**COUNTY OF SAN MATEO
PLANNING AND BUILDING DEPARTMENT**

DATE: November 9, 2018

SUBJECT: Consideration and approval of a detailed landscaping plan for the Ascension Heights Subdivision approved on appeal by the Board of Supervisors. The project is located in the unincorporated San Mateo Highlands area of San Mateo County. A condition of approval requires the applicant is to submit a landscaping plan for review and approval by the Planning Commission, including a 30-day public review and comment period before recordation of the Final Map.

County File Numbers: PLN 2002-00517
(San Mateo Real Estate and Construction)

**PROTOTYPICAL
 REAR YARD
 LANDSCAPE
 LOTS 2 AND 5**

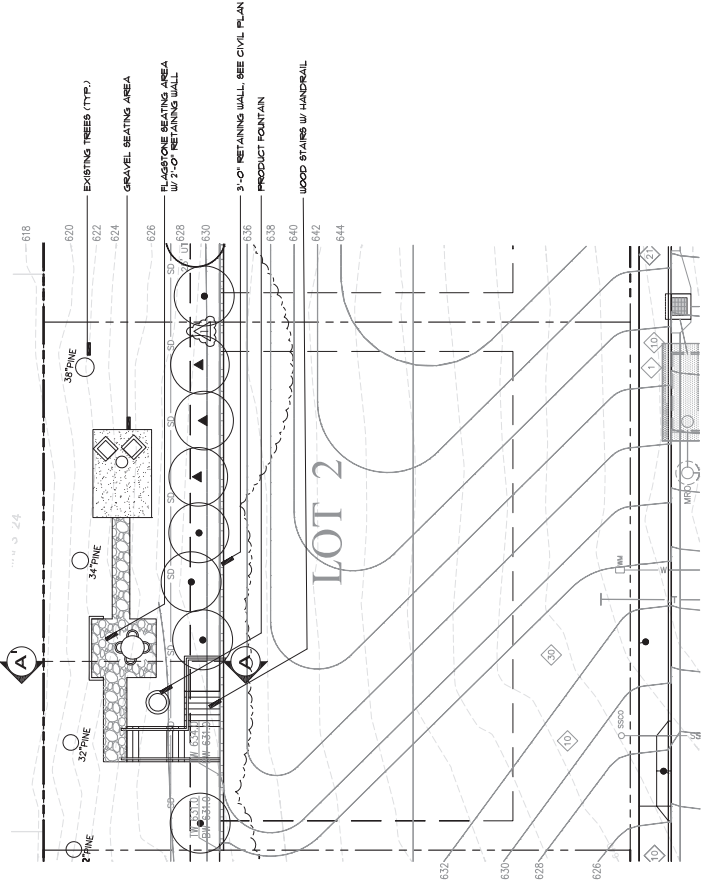
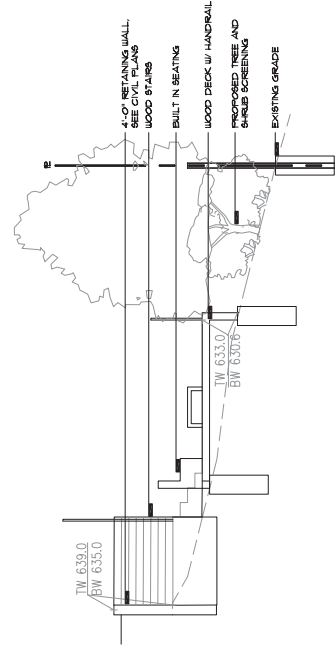
As part of the detailed landscape plan, the applicant has also provided a list of landscape improvement inclusions and exclusions to be incorporated into the Covenants, Conditions & Restrictions (CC&R). These landscape improvement inclusions/exclusions will clarify to future property owners, and the homeowners association the type of improvements they will be allowed to install in their rear yard, not including any structures as defined in the County's regulations; i.e., a "structure," is any ground level structure greater than 18 inches in height above grade. Items listed for inclusion include plantings and irrigation, on-grade flagstone, concrete patios and/or wood decks below 18 inches in height, landscaping elements no larger than five (5) feet wide and five (5) feet tall (i.e. fountains, pilasters, pilasters, decorative landscaping elements), movable and non-attached/ anchored landscaping furniture, and 12-volt lighting. A prototype sample of two scenarios are included as part of the detailed plan on page LP-1.

Staff believes the proposed items listed, as constrained are appropriate given that they don't constitute a structure by definition.
